STANDARD DEPARTURE CHART-INSTRUMENT

RJFN / NYUTABARU

NIPPO SEVEN DEPARTURE

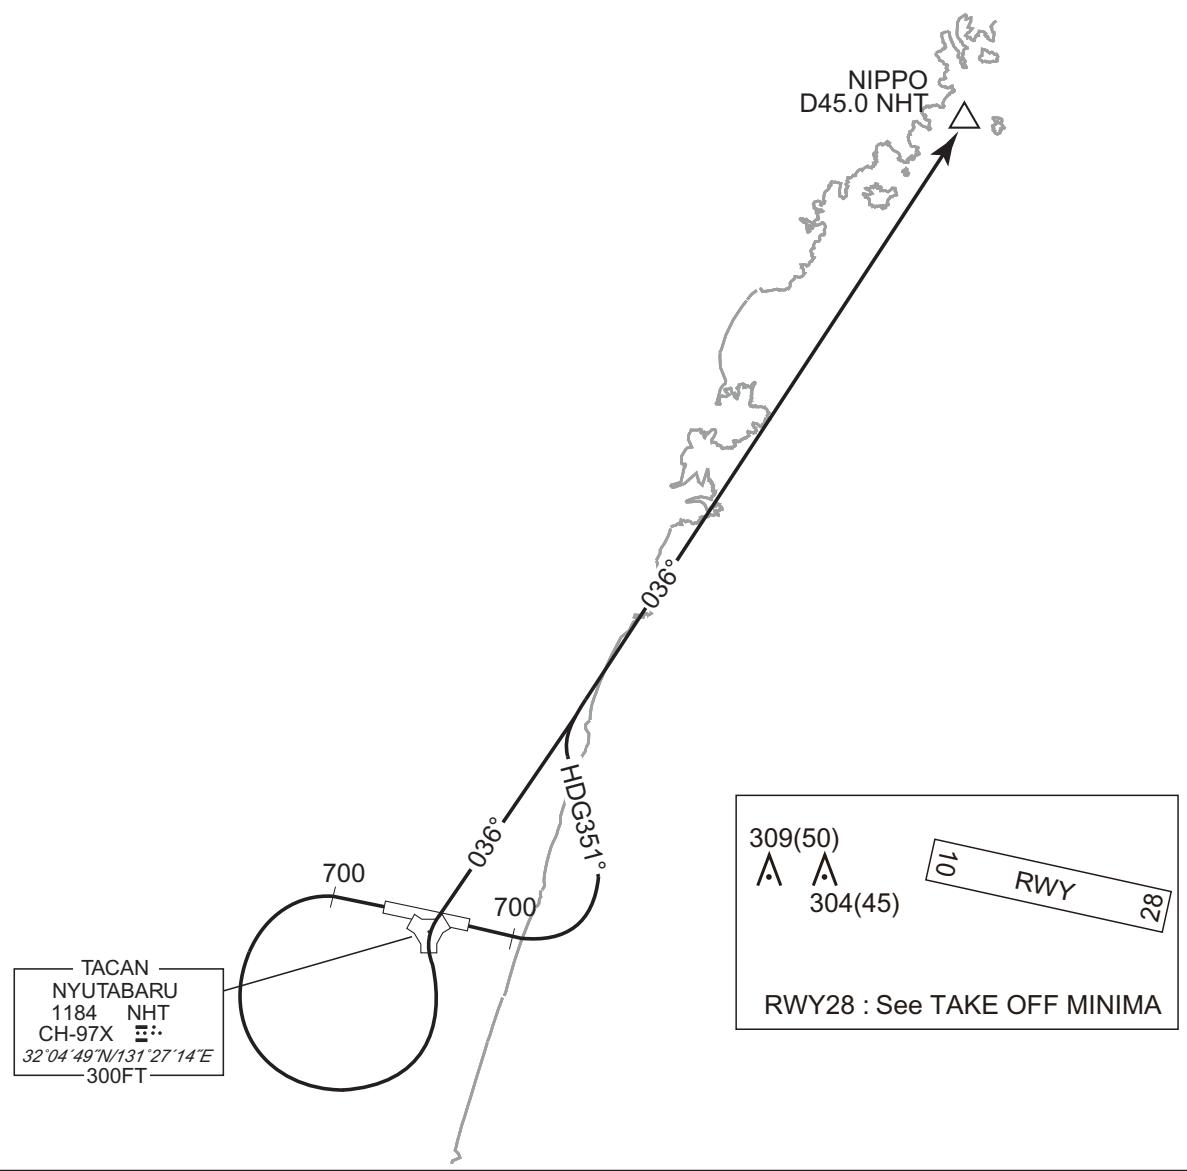
CHANGE : PROC renamed(NIPPO SEVEN DEPARTURE). PROC course(NIPPO SEVEN DEPARTURE). YATOGI TWO DEPARTURE abolished.
Restriction. Note, OBST added.

TENSO FOUR DEPARTURE

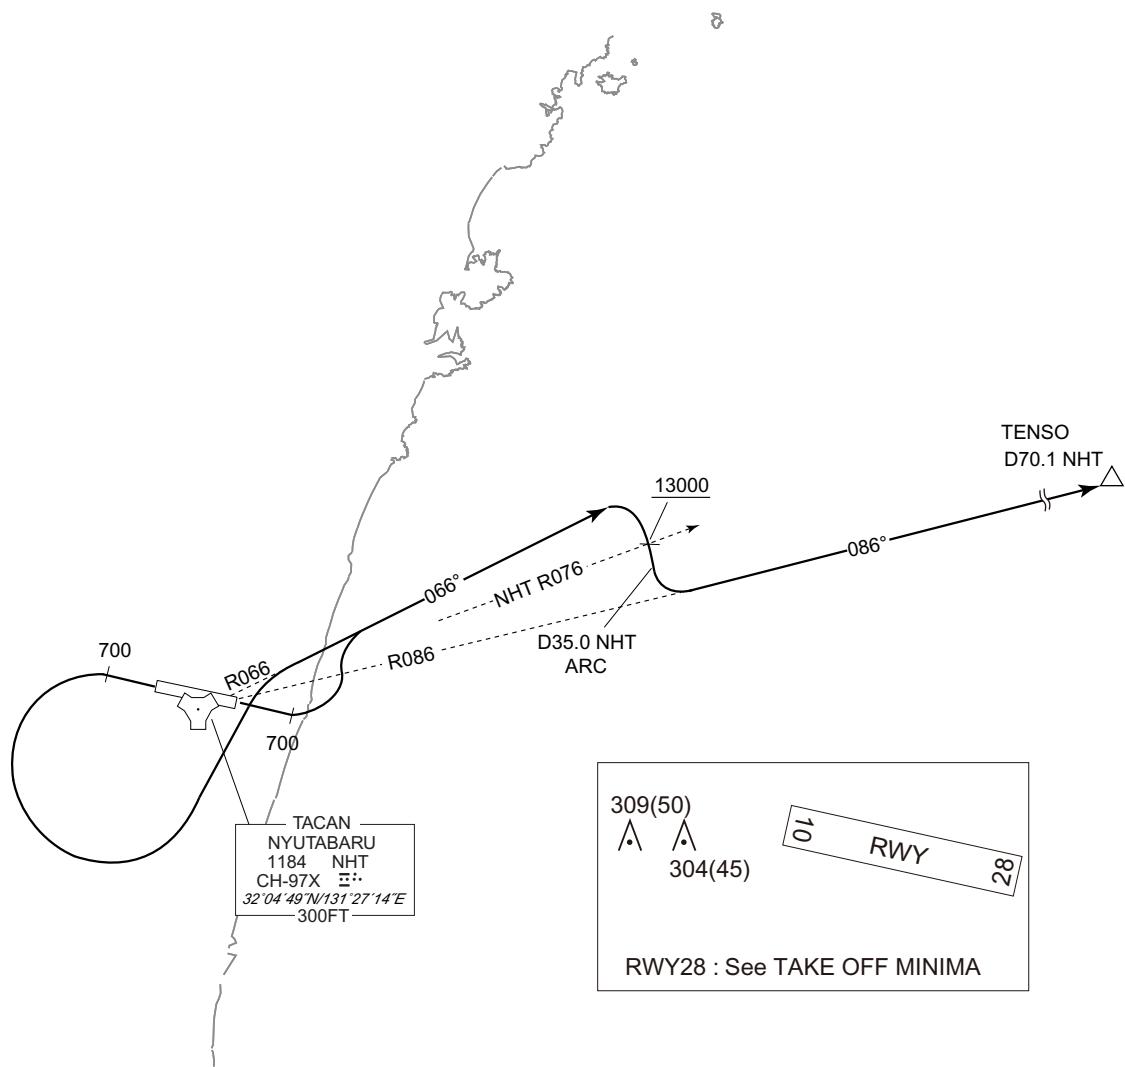
CHANGE : PROC renamed. PROC course. Restriction. Note, OBST added.

SAITO ONE DEPARTURE

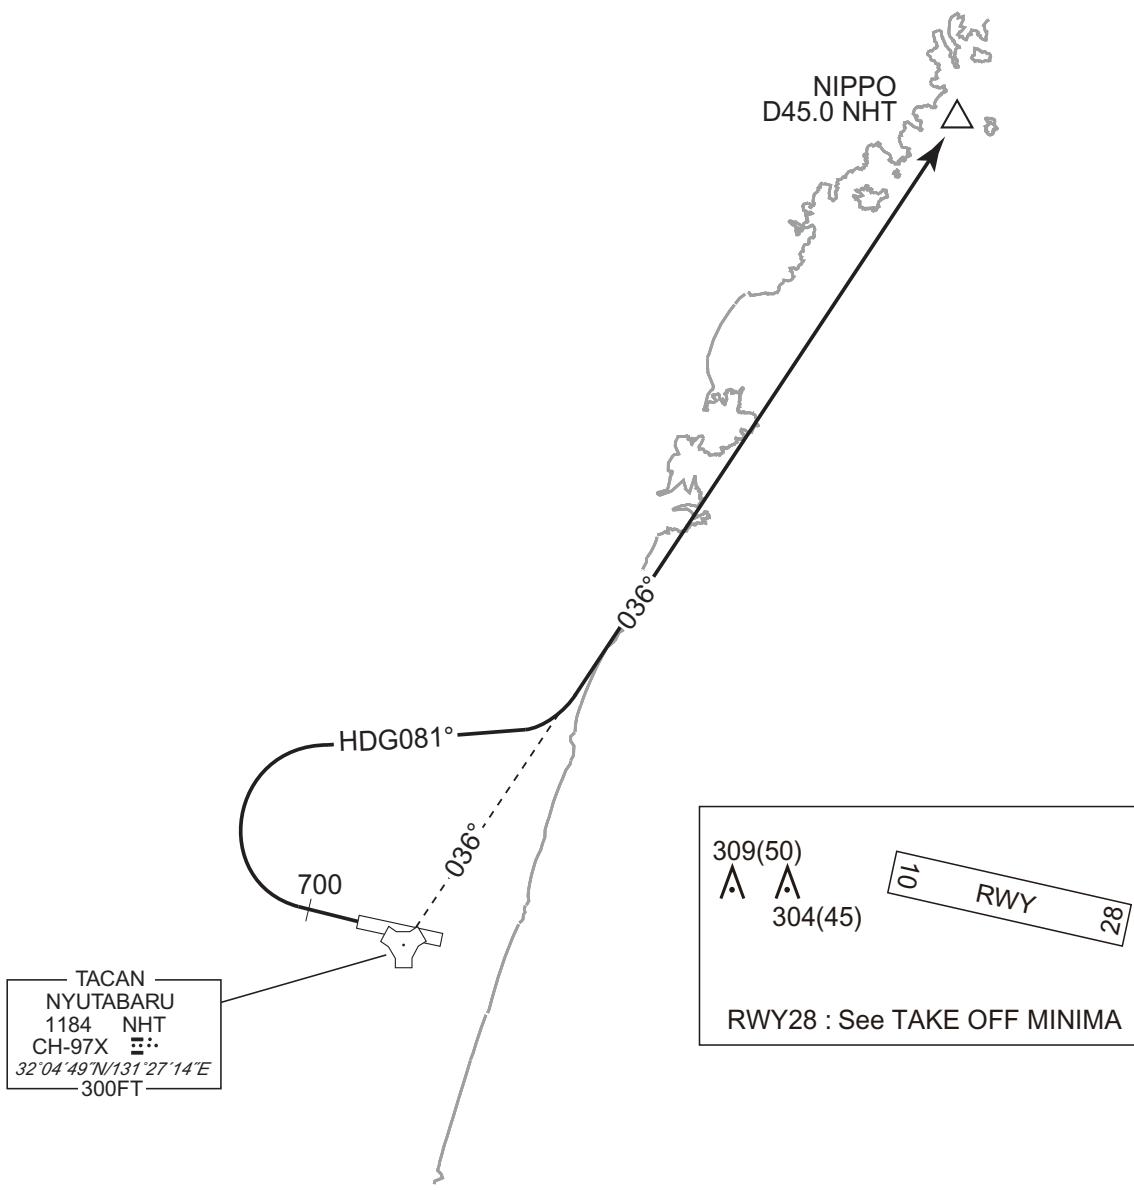
CHANGE : New PROC.

TRANSITION

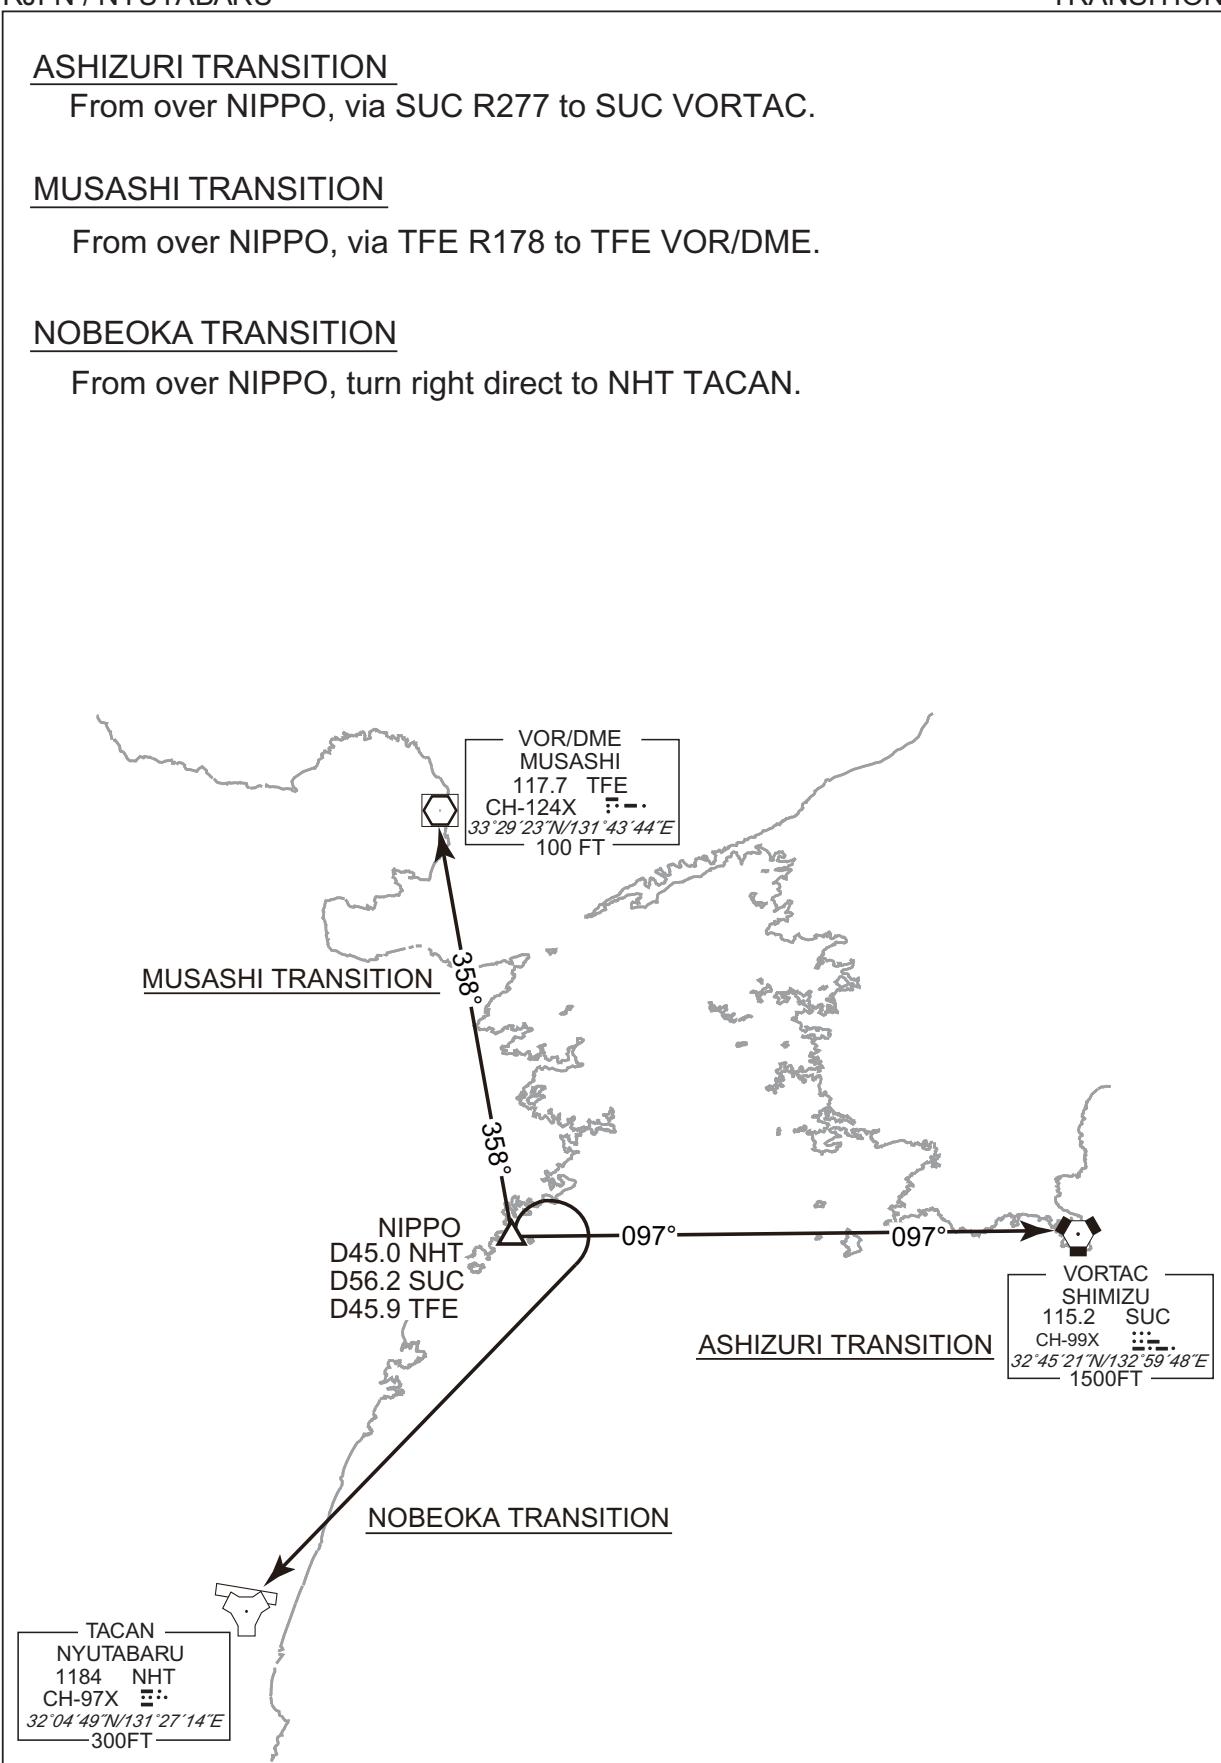
CHANGE : PROC course(NOBEOKA TRANSITION). Description of ASHIZURI TRANSITION, MUSASHI TRANSITION. ALT restriction.
SOBO TRANSITION abolished.

TENSO ARRIVAL

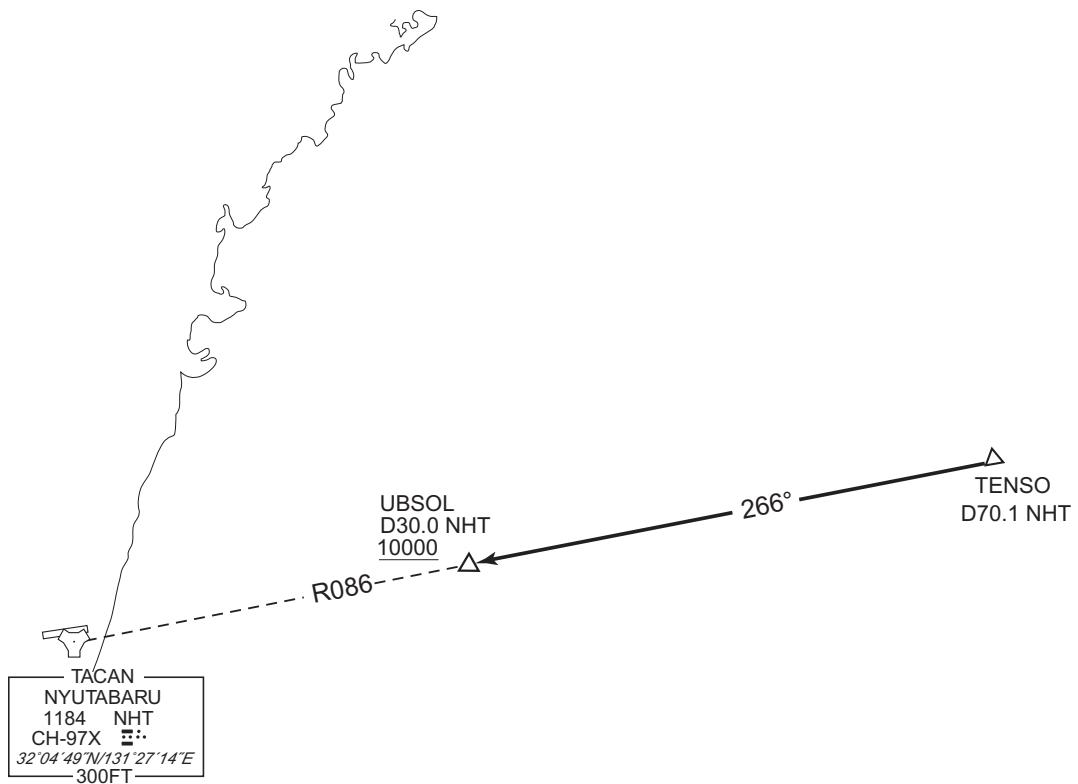
CHANGE : PROC course. UBSOL established. ALT restriction.

INSTRUMENT APPROACH CHART

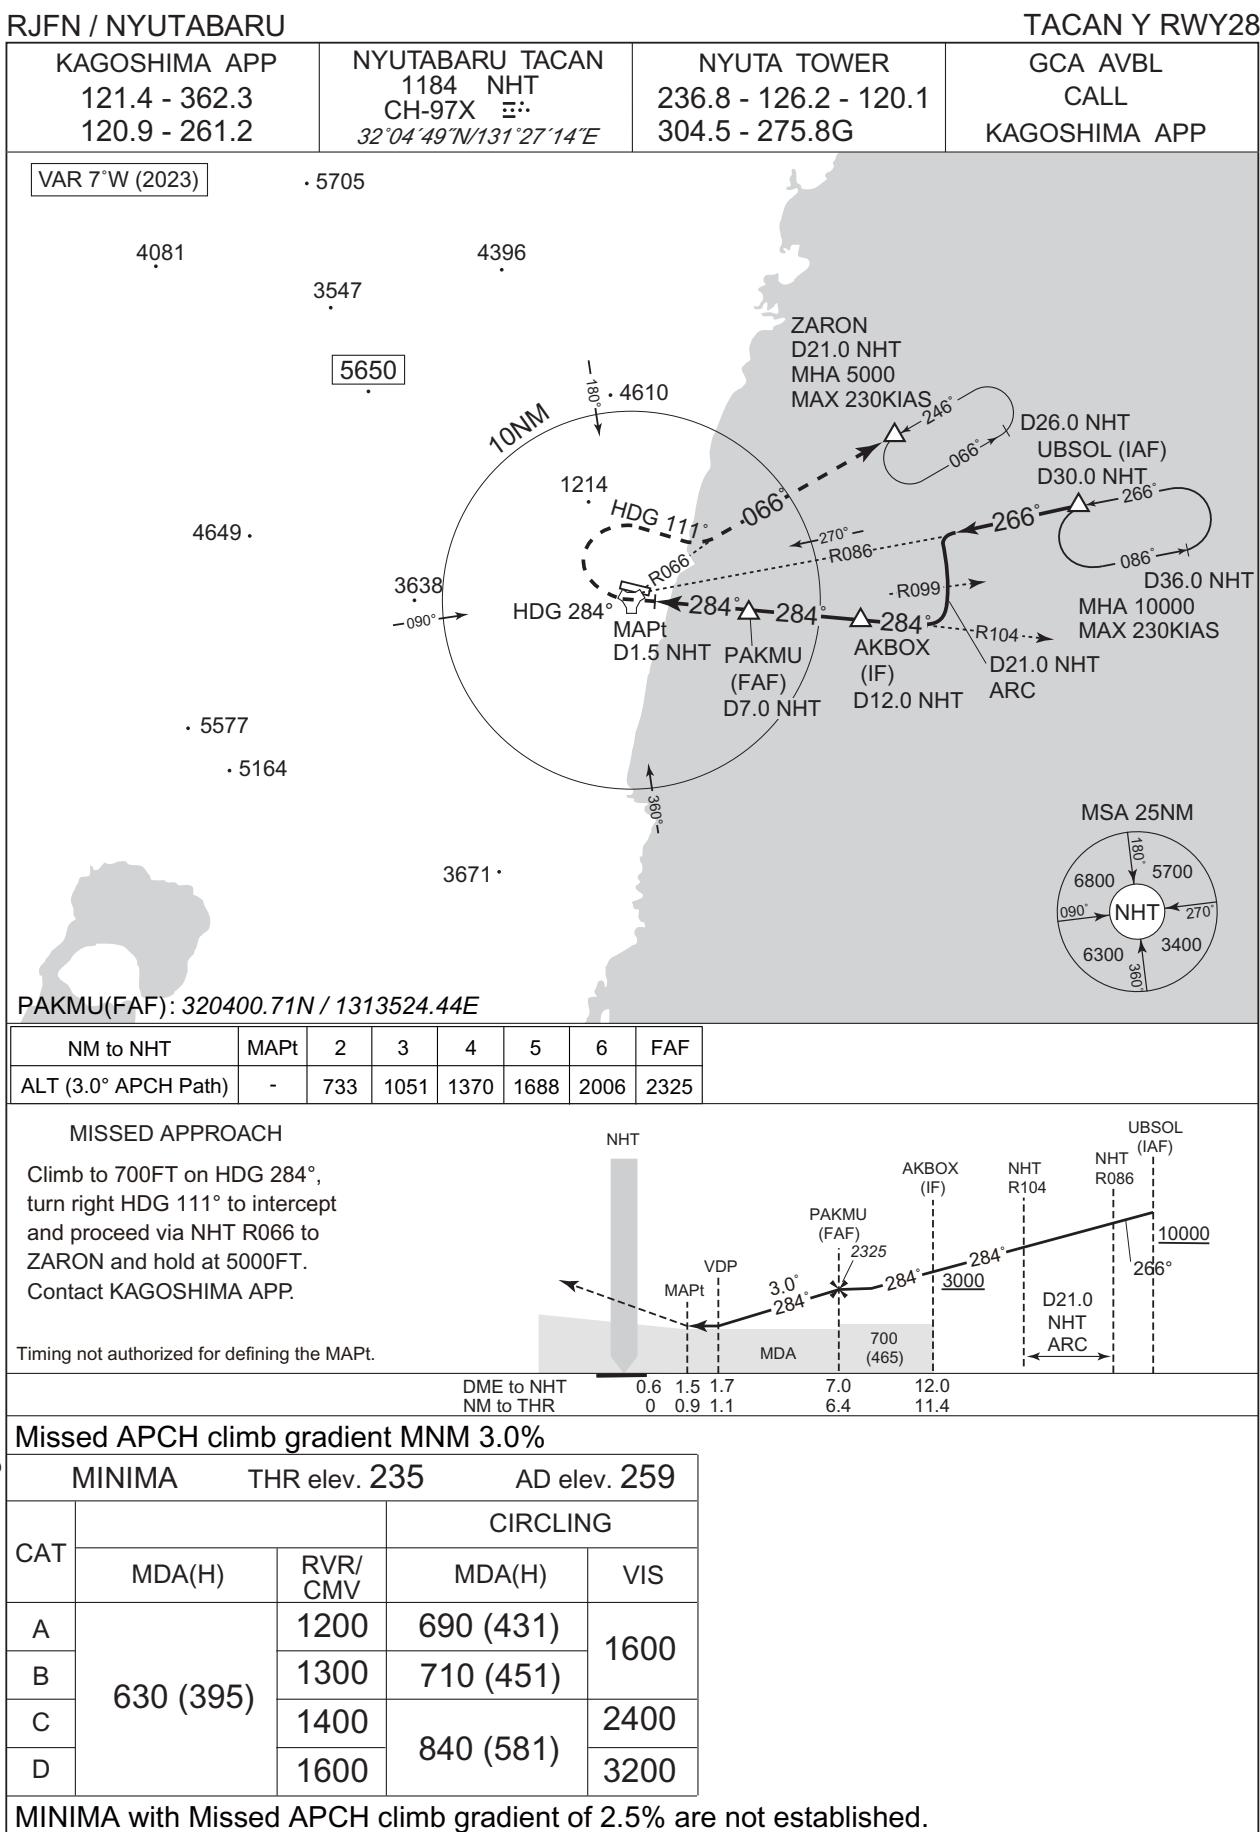
CHANGE : PROC course. Missed APCH course. MINIMA. UBSOL, PAKMU added. VAR. Missed APCH climb gradient MNM added. VAR.

INSTRUMENT APPROACH CHART

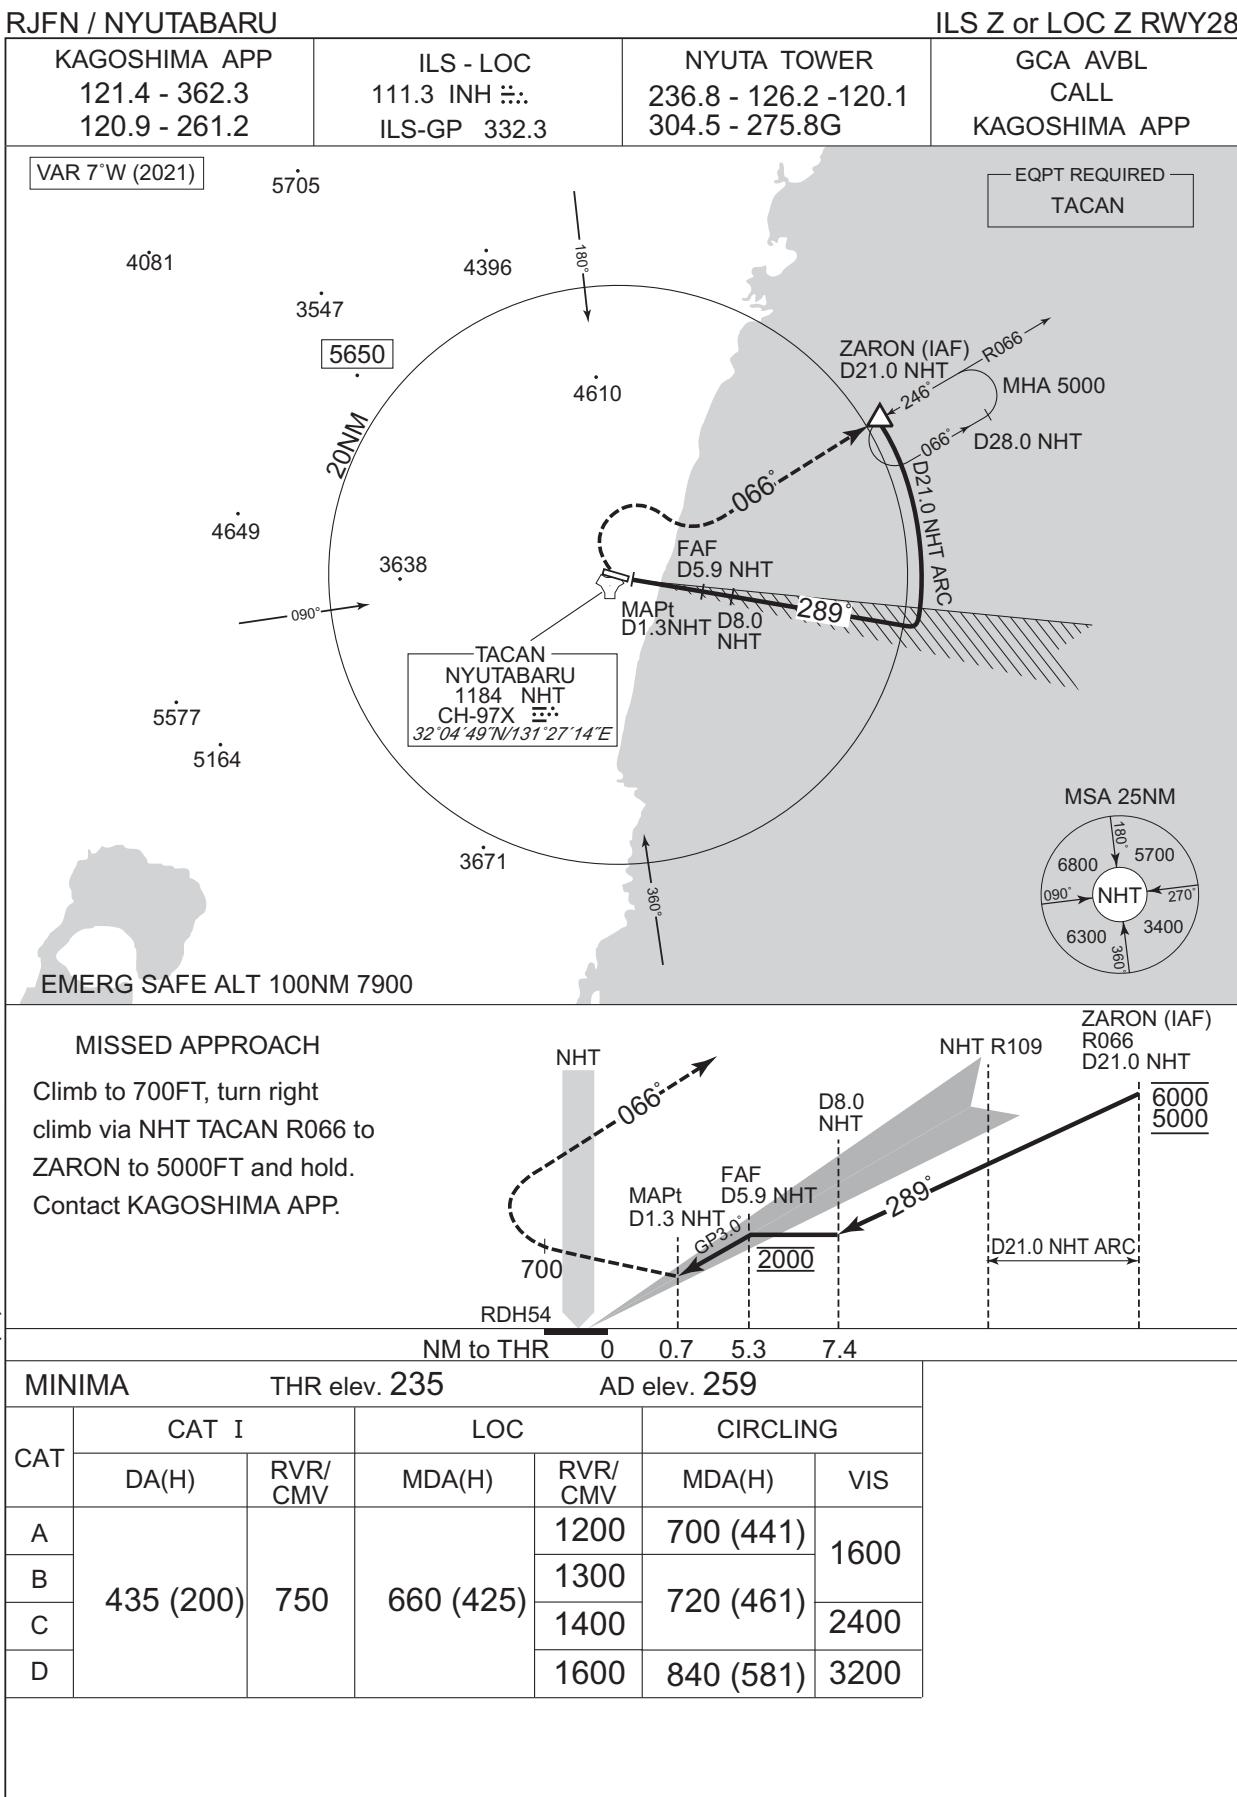
CHANGE : VAR PROC renamed. EQPT REQUIRED added. PROC course. MISSED APPROACH course. MSA.
NM to THR added. MDA(H) for CIRCLING.
